DESCRIPTION OF PROPOSED CHANGES

- Technical Specification 3.8.1.2 ELECTRICAL POWER SYSTEMS, A.C. SOURCES, SHUTDOWN

TEMPORARY DIESEL GENERATOR ADDITION SINGLE LINE DIAGRAM

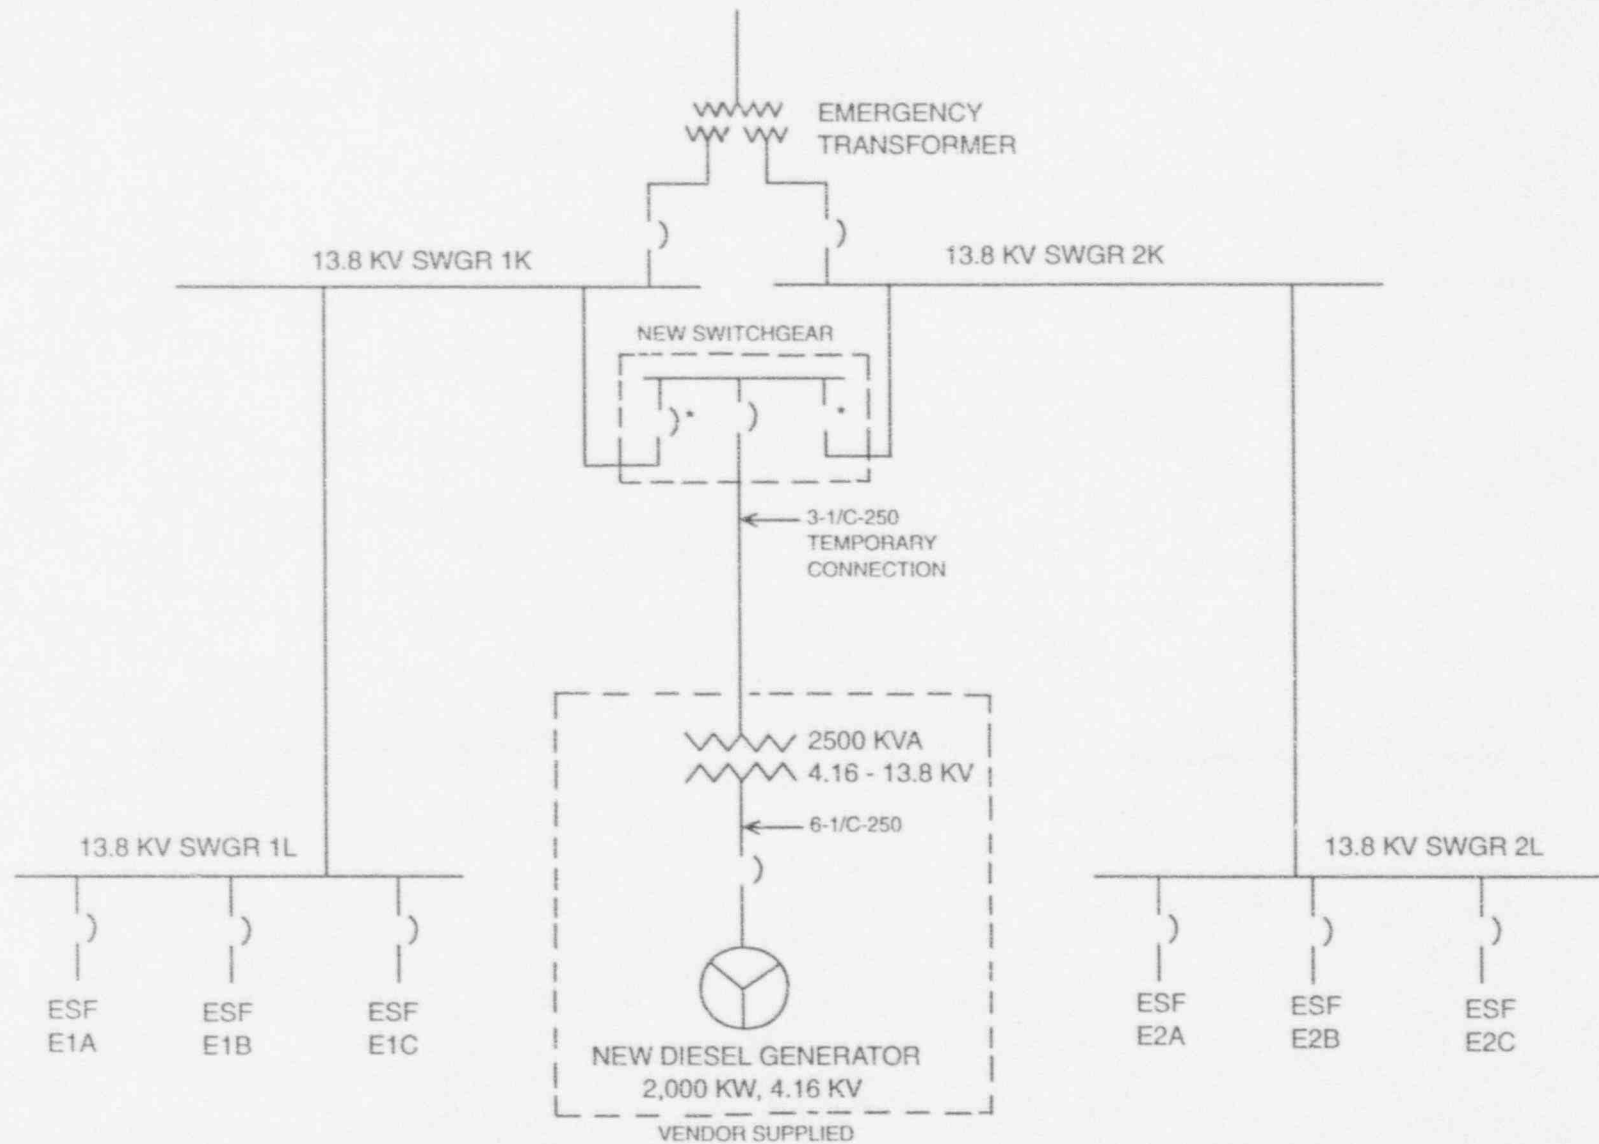
In order to provide operating and maintenance flexibility during reduced reactor coolant inventory conditions, a note to proposed specification 3.8.1.3 states that an alternate onsite emergency power source may be substituted for one of the required Standby Diesel Generators. For the upcoming Unit 1 refueling outage, Houston Lighting & Power is planning to rent a diesel generator unit for use as the alternate diesel backed power source. This diesel generator will be non-safety related, non-seismically qualified. The alternate diesel generator will have its own support systems and fuel oil which will also be non safety related.

FIGURE 3
TEMPORARY DIESEL GENERATOR INSTALLATION PLOT PLAN

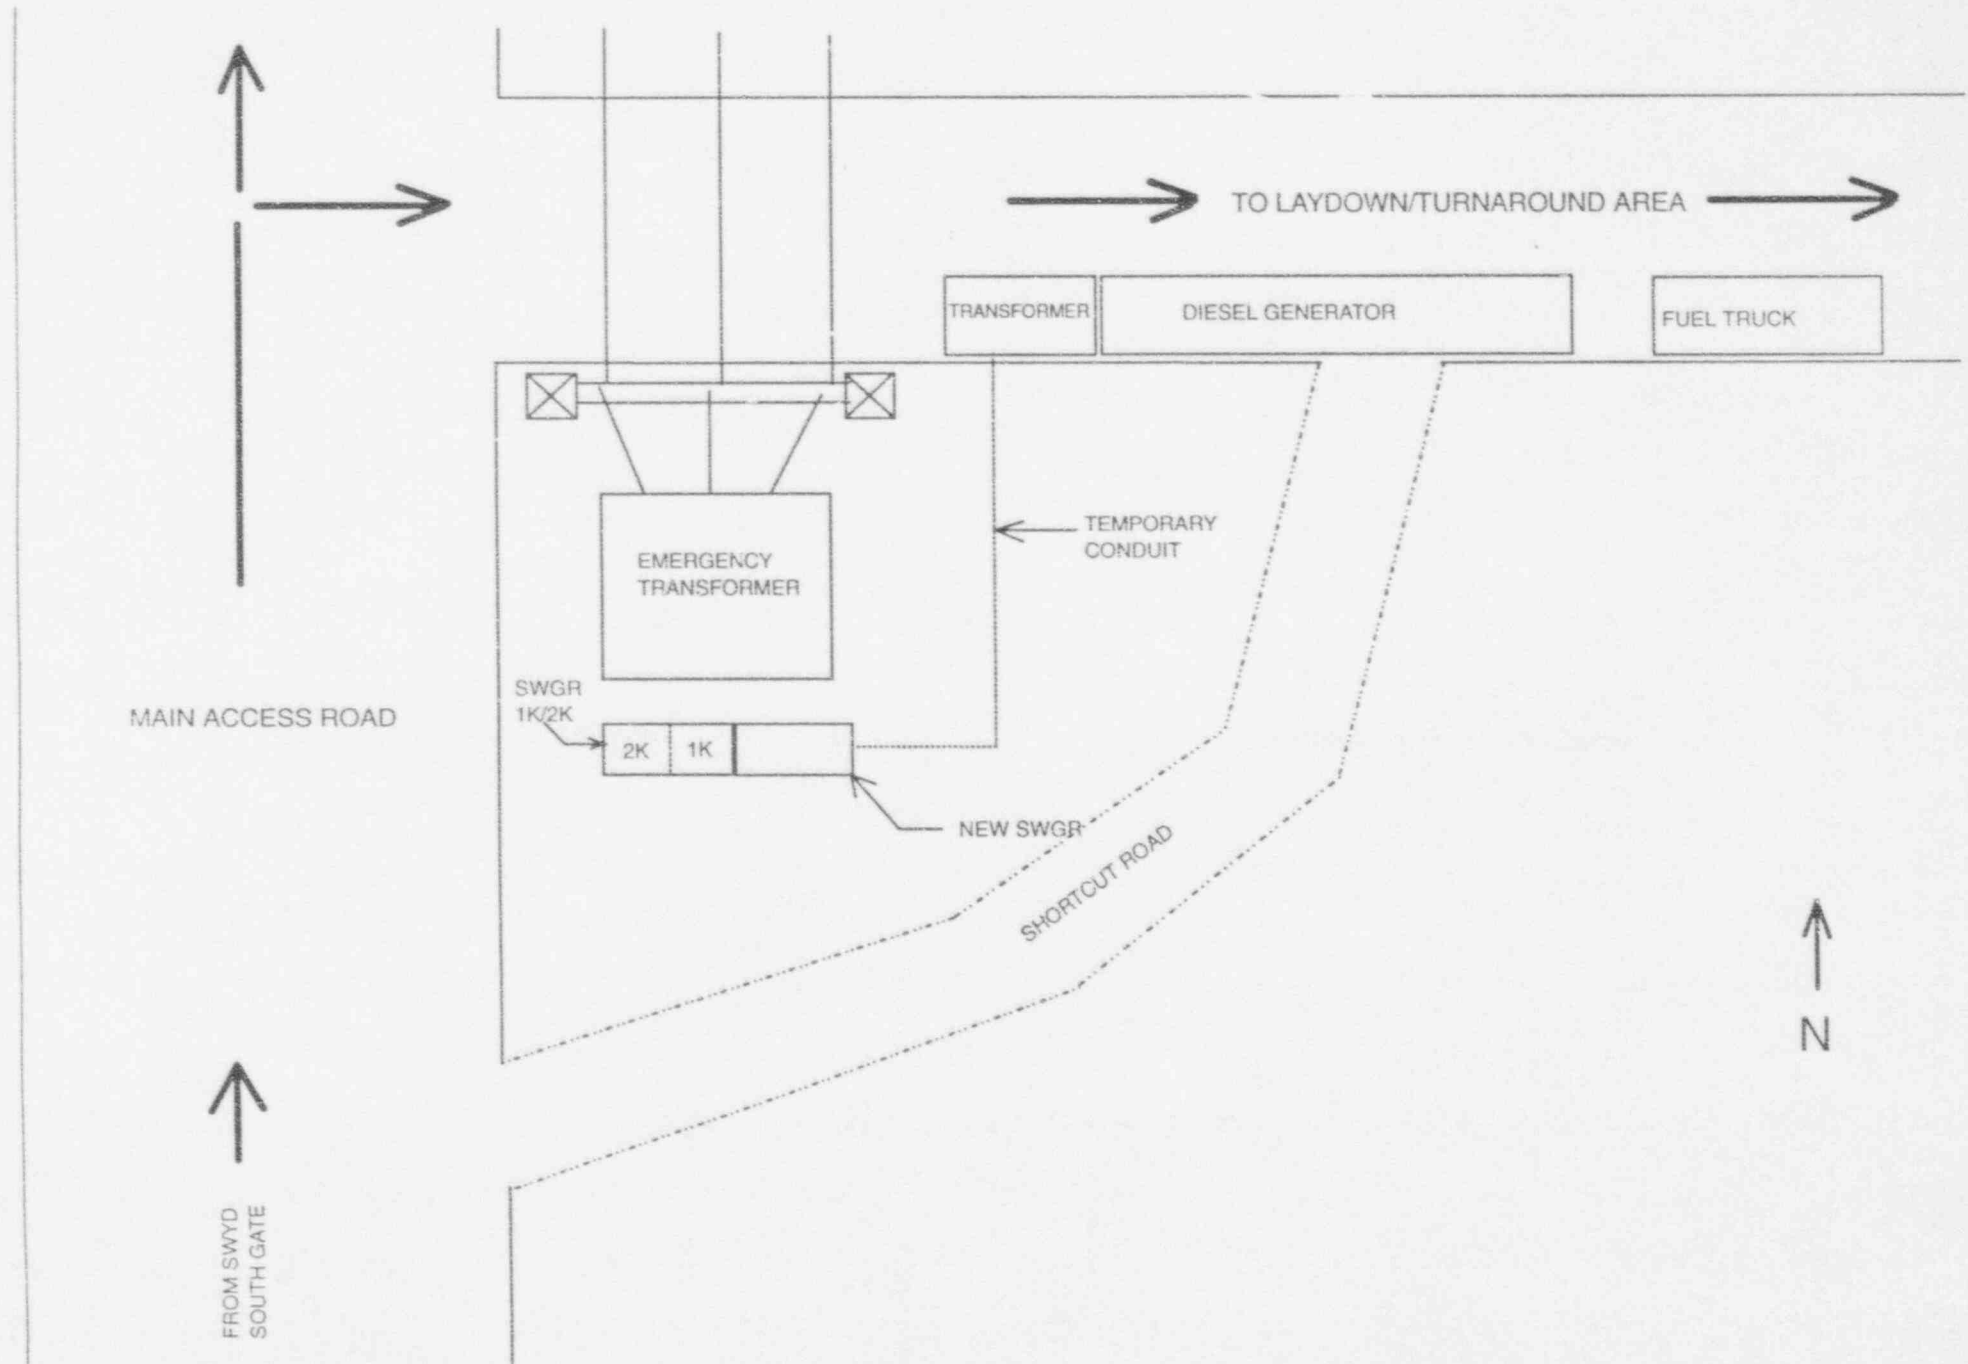
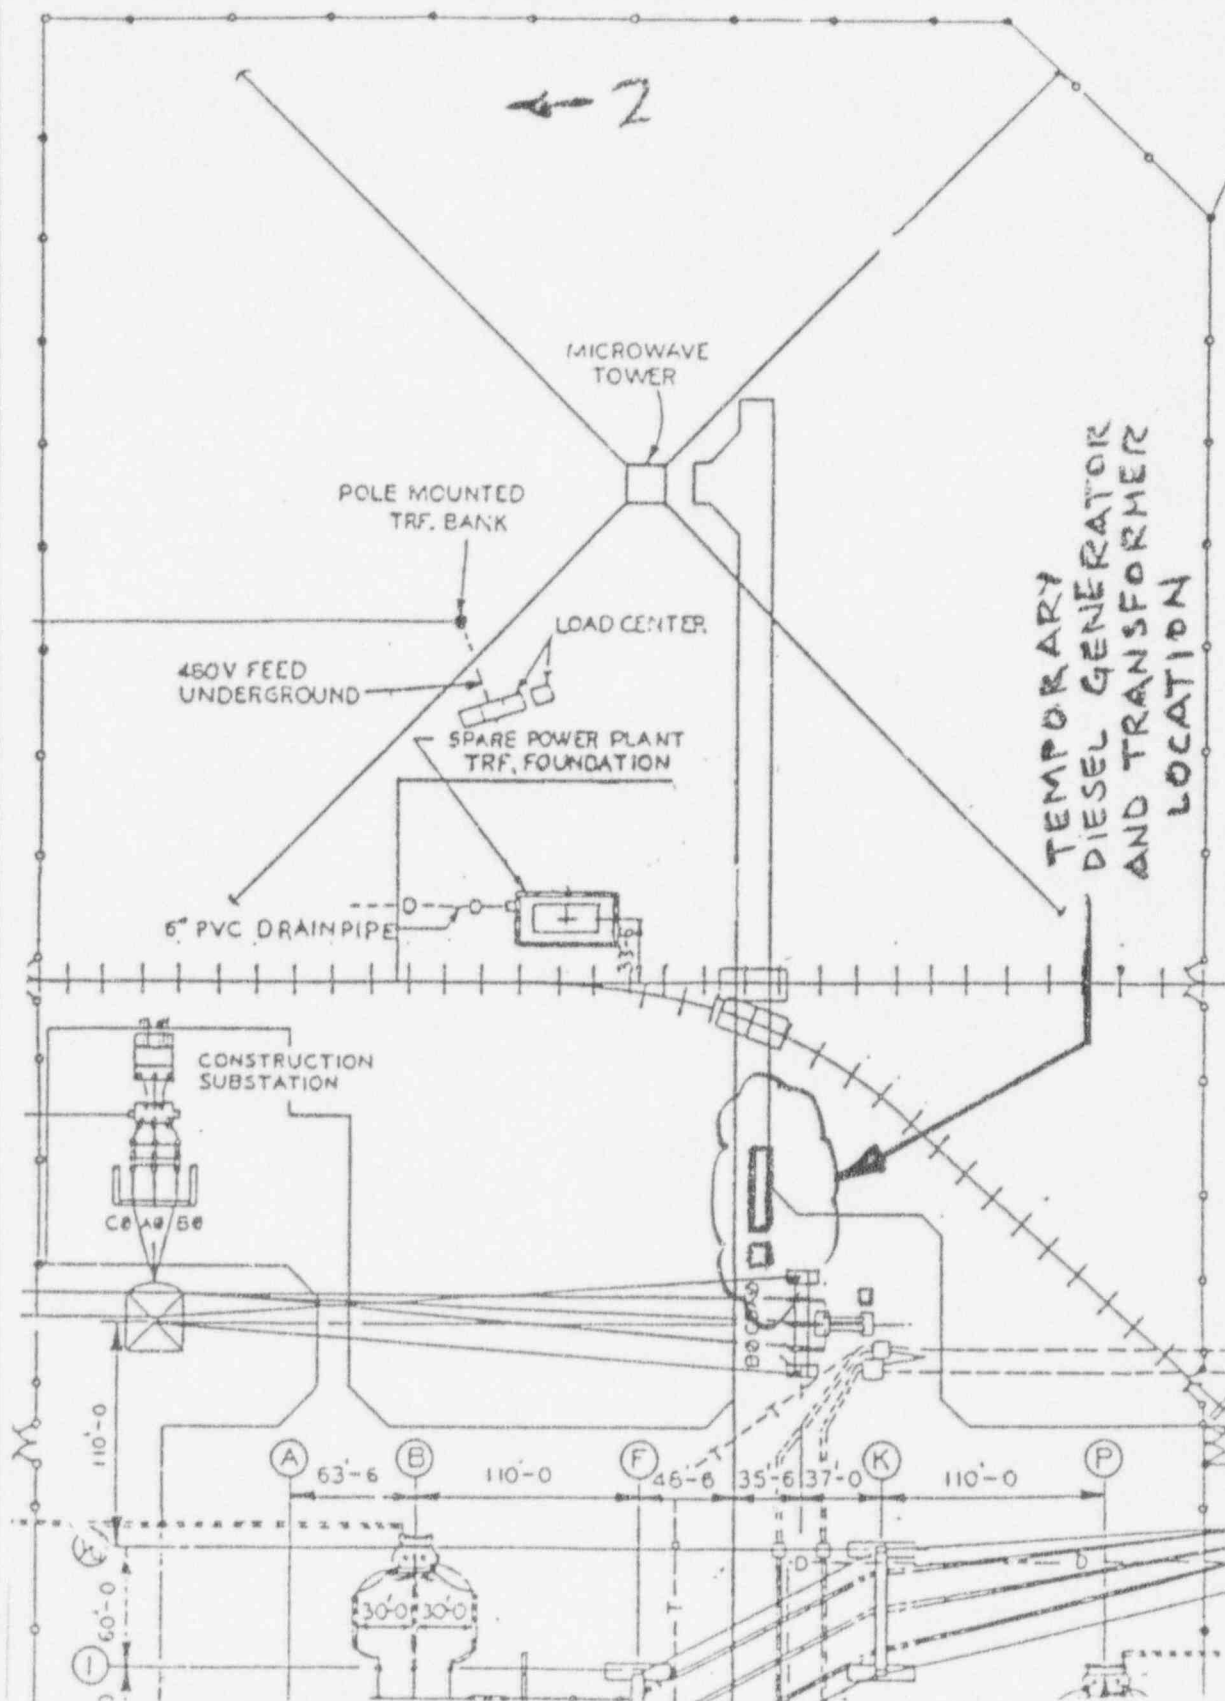
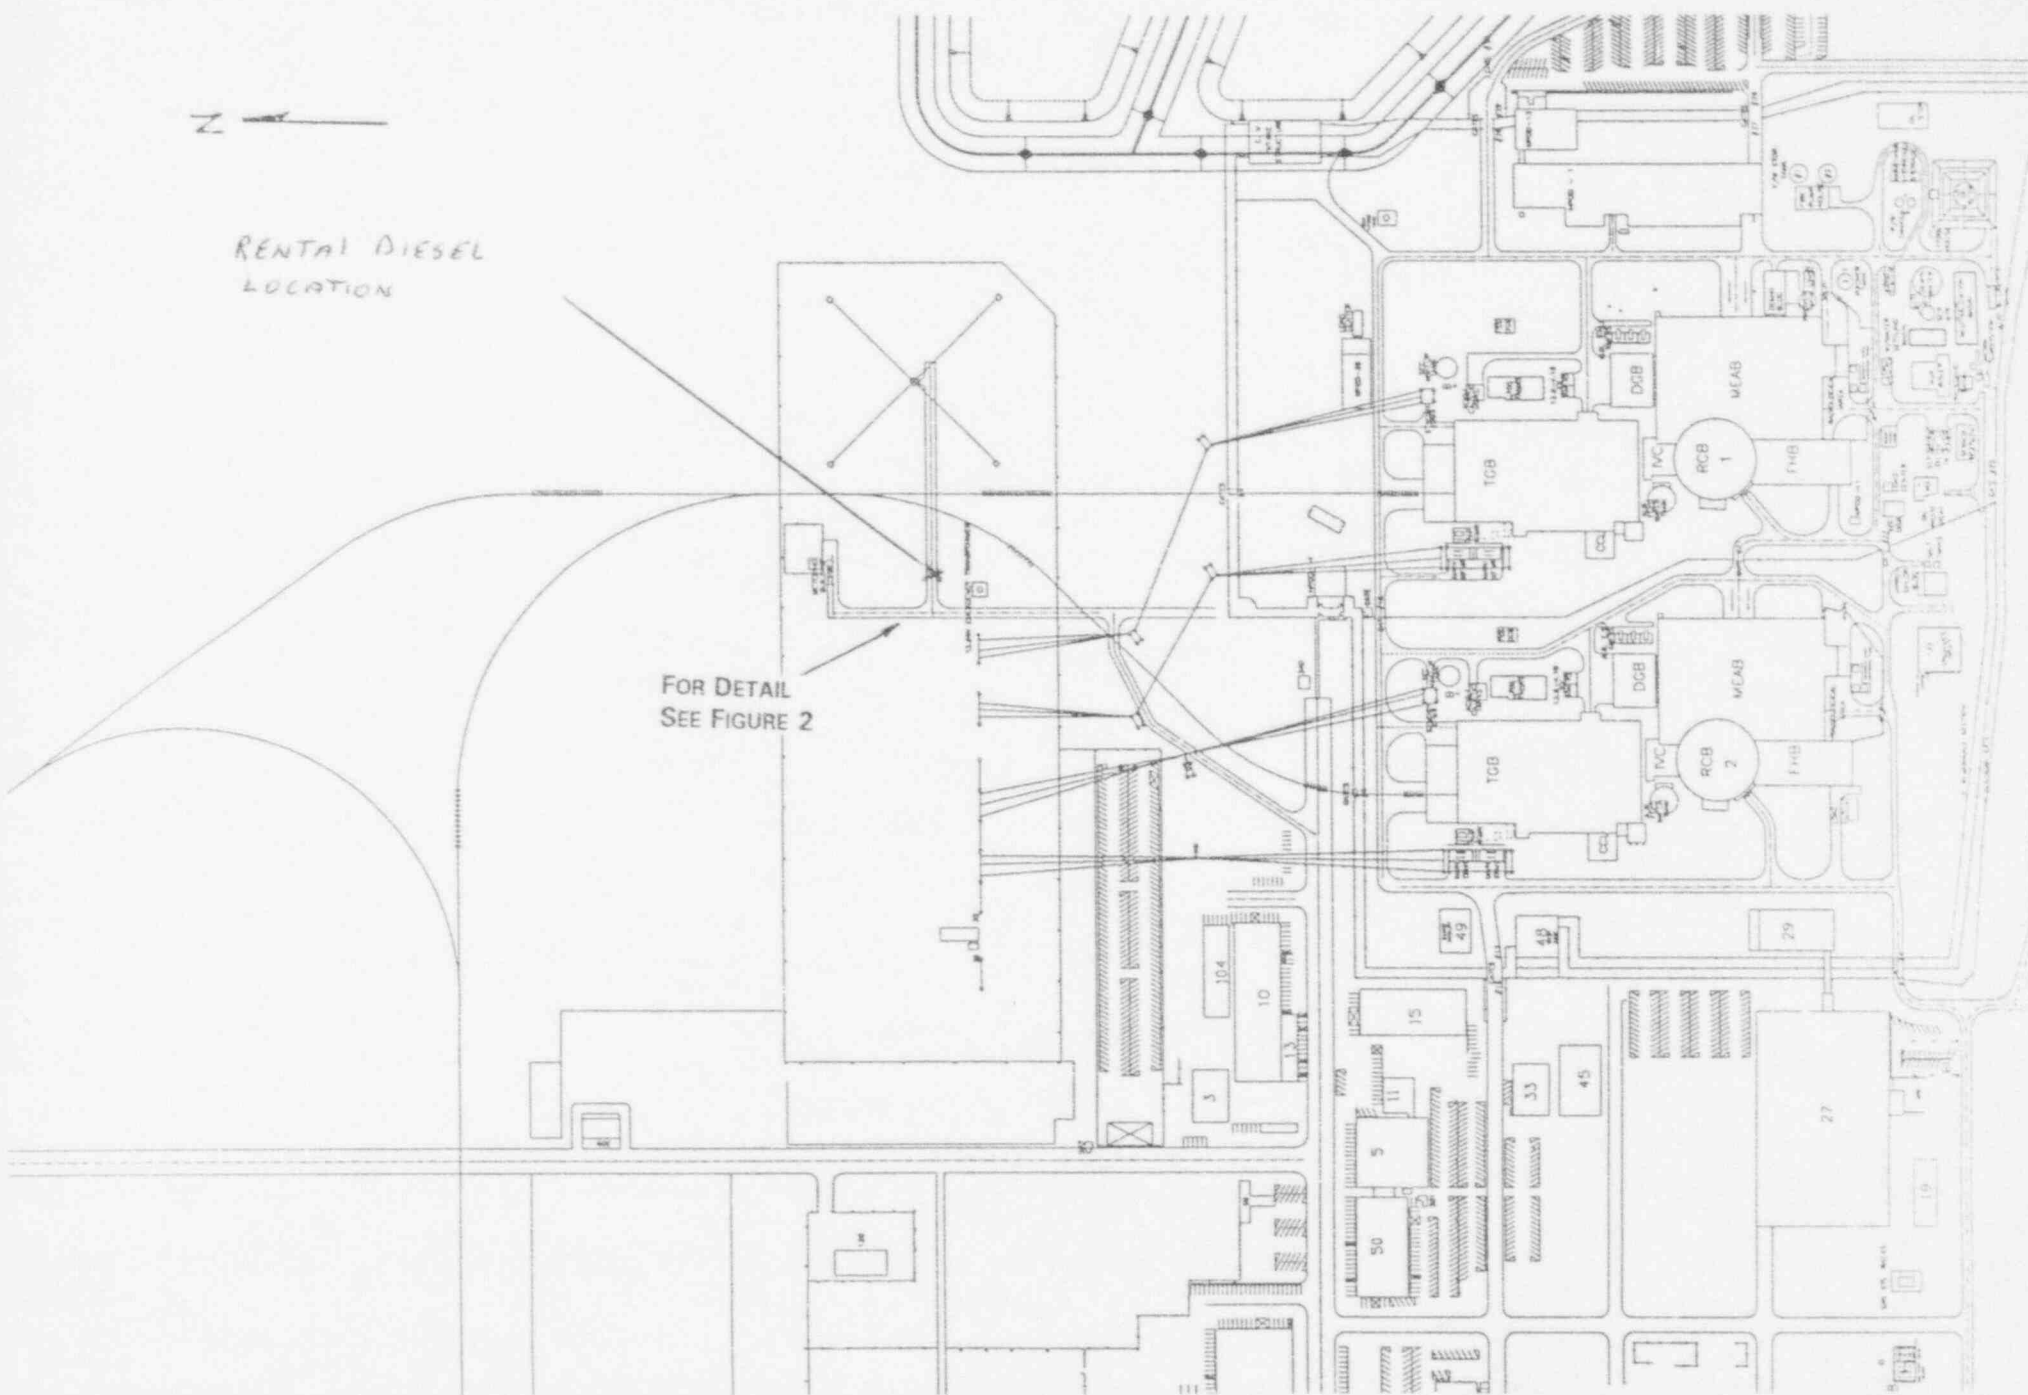
In addition, Houston Lighting & Power is preparing a plant modification which will facilitate the connection of the rental unit to the onsite electrical distribution system. The currently proposed modification will add a new 13.8 kV switchgear bus as shown in Figure 1. The line side of one of the three breaker compartments will be used for connection of the rental unit. The load side of the other two breaker compartments will be permanently connected to the existing Unit 1 and 2 13.8 kV switchgear buses 1K and 2K respectively. Following insertion, racking and closing of the temporary diesel generator unit breaker and either of the other new switchgear breakers, the rental unit can be used to power any 4.16 kV Engineered Safety Features bus of either South Texas Project unit. At this time, Houston Lighting & Power plans to prohibit the cross-tie of the units by administrative controls. The currently proposed location of the new switchgear and rental unit is shown on Figures 2, 3 and 4.
